PCN

Change of electrode design for A8, N8 and P8 series of surge arresters

221028PPD1e

Product / Process Change Notification

Comparison of old and new electrode

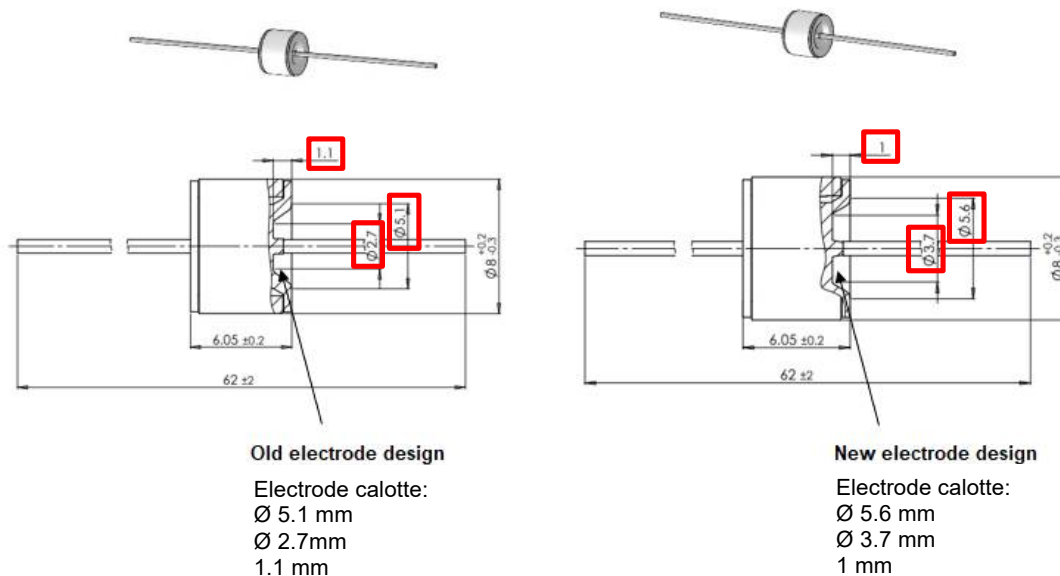
The electrode design of the EPCOS surge arrester series A8, N8 and P8 produced in our plant in Xiaogan/China will be slightly changed. The dimensions of the components remain unchanged, except for minor modifications to the calotte of the electrode.

4. Description of change The design of the electrode will be slightly changed. The dimensions of the components remain unchanged, except for minor modifications to the calotte of the electrode (see drawing for details).
